# UNITED STATES PATENT AND TRADEMARK OFFICE

APPLICATION NO.	FILING DATE	FIRST NAMED INVENTOR	ATTORNEY DOCKET NO.	CONFIRMATION NO.
10/528,917	03/23/2005	Peter R Ebner	MAX 02.01CIP	9044

**Office Action Summary**

## **DETAILED ACTION**

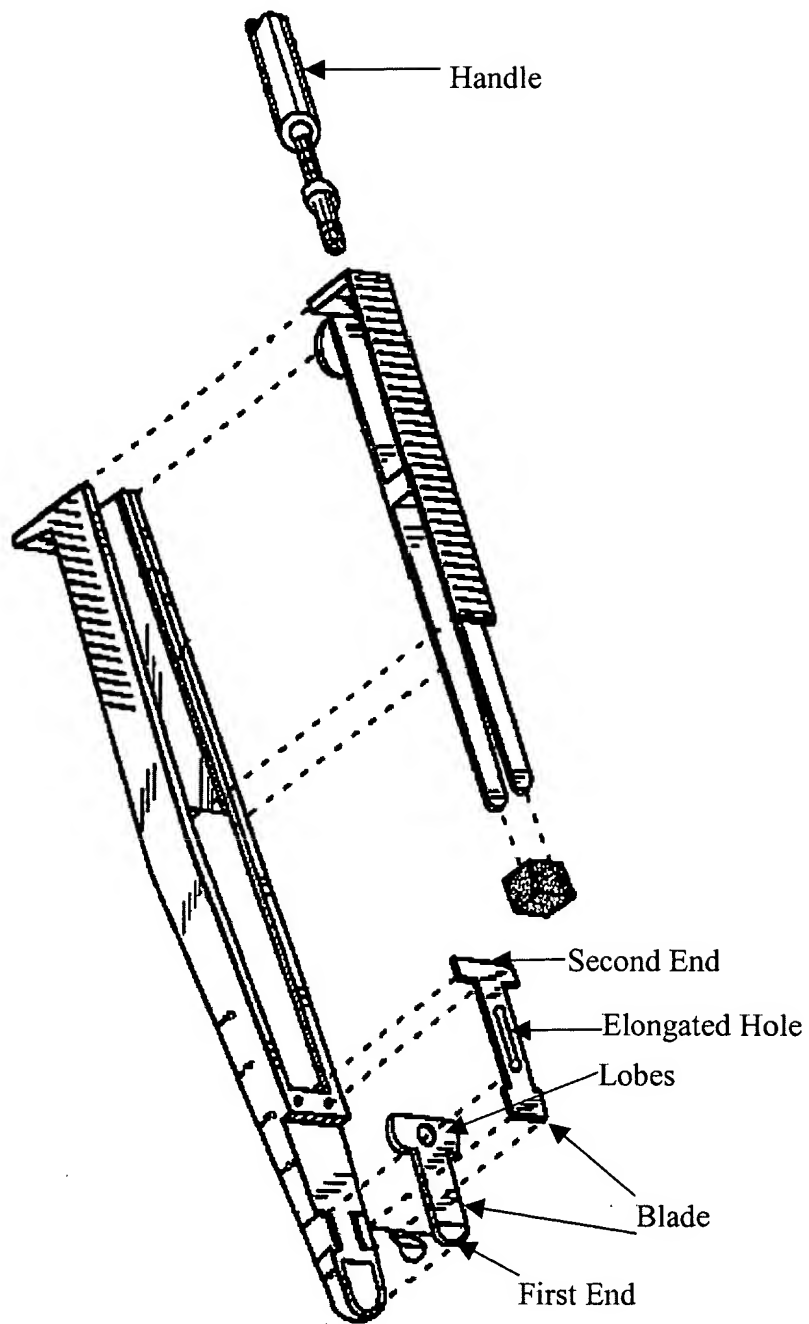
5. Claims 1, 70, 86, and 89 are rejected under 35 U.S.C. 102(b) as being anticipated by Altobelli (U.S. Patent 5,683,406).

Regarding claims 1 and 86, Altobelli discloses an instrument comprising a generally planar blade, a collection chamber with an upstanding retention member, and an elongated handle coupled to the end of the collection chamber (see Figure 1 below). The blade comprises a first end, a second end, and a middle section. The first end comprises a cutting edge and an opening. The middle section comprises at least one outwardly extending lobe. Altobelli also discloses that the collection chamber of the instrument can be used as a mixing chamber (column 4 lines 61-67; claim 86).

Regarding claims 70 and 89, Altobelli discloses a blade comprising a first end, a second end, and a middle section. The first end of the blade comprises a cutting edge and an opening. The middle section of the blade comprises a pair of extending lobes on either side of a centrally located elongated opening. Regarding 89, Altobelli discloses a blade wherein the second end comprises two protrusions to facilitate the extraction of the blade from the collection chamber.
